## **Central Planning Authority**

**Minutes of a meeting of the Central Planning Authority held on September 1, 2021 at 10:00 a.m. in Conference Room 1038, 1<sup>st</sup> Floor, Government Administration Building, Elgin Avenue.**

**CPA/18/21**

Figure 3: Survey data showing shoreline position/MWHM from 2003 to 2019 on 2018 aerial imagery

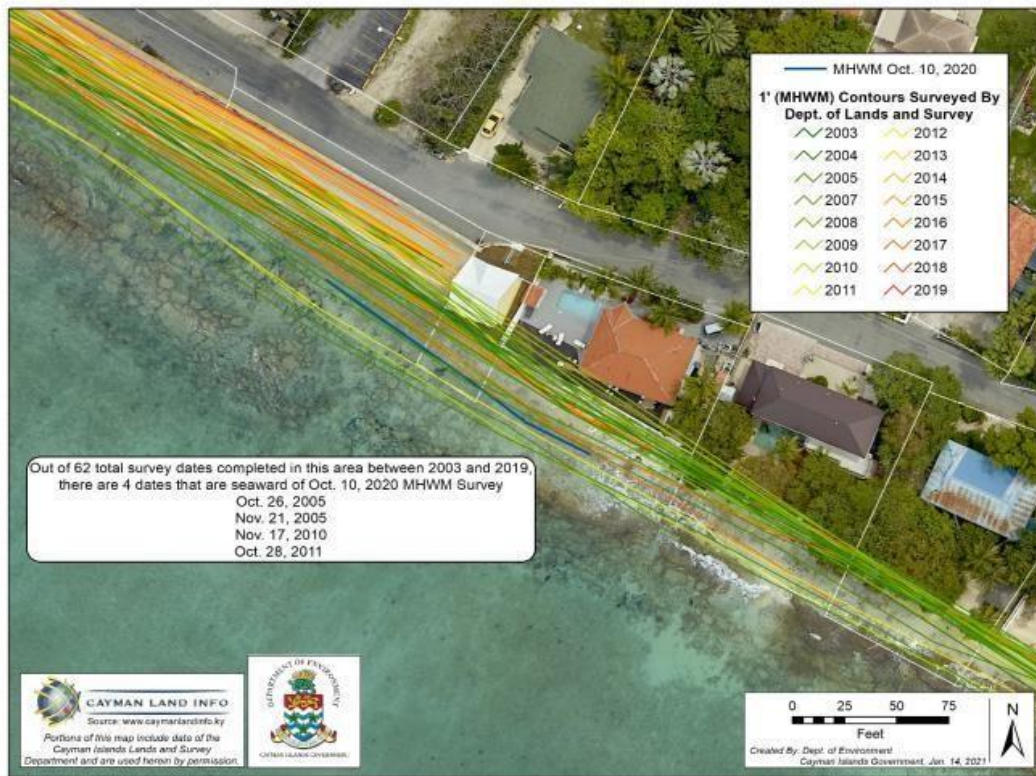
Figure 3 shows the surveyed position of the shoreline/MHWM at frequent time intervals from 2003 to 2019 (approximately monthly), based on survey data collected by the Department of Lands & Survey. Out of a total of 62 surveys undertaken in this location between 2003 and 2019, there were only 4 dates when the beach existed seaward of the October 2020 MHWM. Of these, the October and November 2005 accretion events can be attributed to Hurricane Wilma. The October 2011 accretion may be attributed to Hurricane Rina. Furthermore, as can be seen from Figure 3, the beach was completely absent for many of the survey dates (22).

*The current MHW survey reveals that the current seawall forms the boundary with the sea, and to the west of the site, incursion of the sea can be sea up to the Boggy Sand Road sheet piled seawall. Therefore, whilst the proposed seawall is positioned marginally further inland than the existing, the proposed seawall will also have a 0ft setback from the sea. The proposed cabana will have an 8ft setback from the existing seawall and an even lesser setback from the proposed seawall location.*

Figure 4. Seawalls cause scour as the energy is reflected by the seawall.

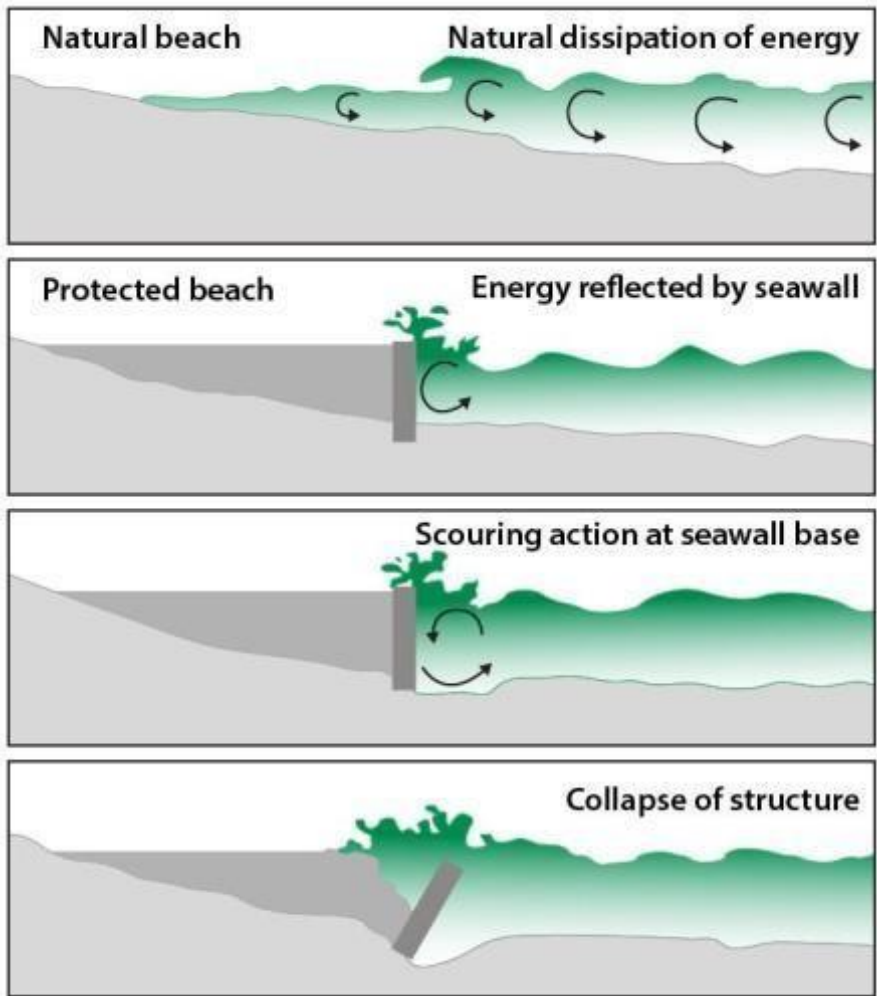
Hard structures such as seawalls on a beach, restrict the natural sand deposition processes. On a natural undeveloped beach, waves roll up the beach, depositing sand as they lose energy. However, seawalls interfere with this process. When waves hit a seawall, the energy is directed downwards and sideways. When the energy is directed downwards, the waves scoop out the sand at the foot of the seawall – called scour (see Figure 4). The existing seawall has caused scour at the site, as detailed in the

Engineering Report which accompanies the planning application. When the energy is directed sideways, the wave flanking can remove sand from neighbouring properties. Therefore, this seawall could also be negatively affecting the beach on adjoining parcels.
